**Re: Planned Construction at 226 Arnold Avenue, Thornhill**

**Subject:** FW: Public Correspondence (Addendum): A034/22 (226 Arnold Ave)

**Figure 1 – Cropped Site Plan of 226 Arnold Avenue showing proposed building footprint. Approximate area of excavation within TPZ of the Silver Maple is indicated. 22.47m<sup>2</sup> equals 19.87% of the TPZ. Closest excavation distance of 2.1m from tree threatens structural instability**

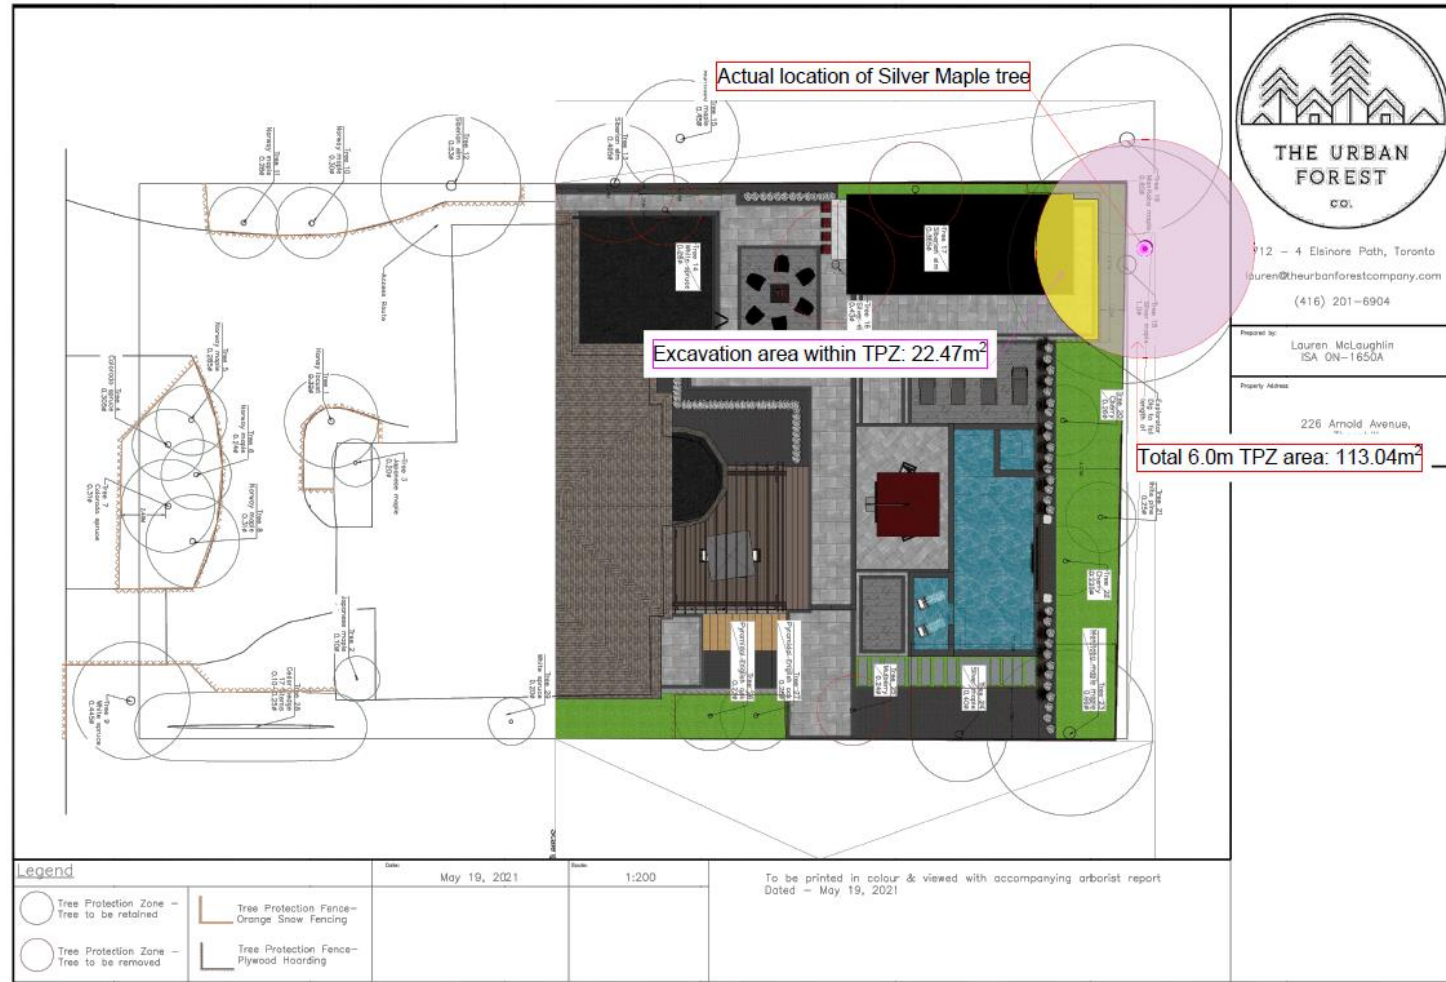
Construction at 226 Arnold Avenue, as planned, would take place well within the 6.0m radius Tree Protection Zone of a 96cm DBH Silver Maple tree belonging to the neighbouring owner at 59 Rodeo Drive. As planned, excavation for building a new interlock patio and cabana would require severance of the root system belonging to the subject tree at 1.26m from its base. This distance correlates to approximately 1.3x the diameter of the tree away from its base. According to research done by Dr. E. Thomas Smiley, trenching for construction is advised to be no less than 3 times the trunk diameter distance from the tree. This correlates to performing excavation at 2.88m away from the subject tree. This would require revised site plans to place the interlock patio at approximately 3m away from the subject tree at the closest point to it.

As planned, construction at 226 Arnold Avenue would require removal of roots within 19.87% of the subject tree's TPZ. This would cause a substantial amount of stress and injury to the tree that it would not likely fully recover from. The removal of roots at the planned proximity to the tree would likely cause a loss of its structural integrity, raising the risk of it falling during high winds. Ideally, construction should take place entirely outside of the Tree Protection Zone distance of 6.0m. However, if a compromise were to be made to permit construction inside the TPZ in a way that ensures the tree's long-term survival and stability, then it is my recommendation that site plans be revised to locate the interlock patio and cabana more than 3.6 meters away from the subject tree, which allows for some additional root space to be preserved considering the tree's lean. I also recommend low impact excavation (hand-digging or air spading), excavation for patio bedding to be no more than 20-30cm and for cabana foundation no more than 60-90 cm deep. This would reduce root and canopy loss, which would assure the tree's long-term recovery from any

injury that would be required to accommodate such a revised construction plan. Such work would still require a Permit to Injure the tree to be approved issued by the City of Vaughan, which is also subject to signature requirement from the homeowner of 59 Rodeo Drive.
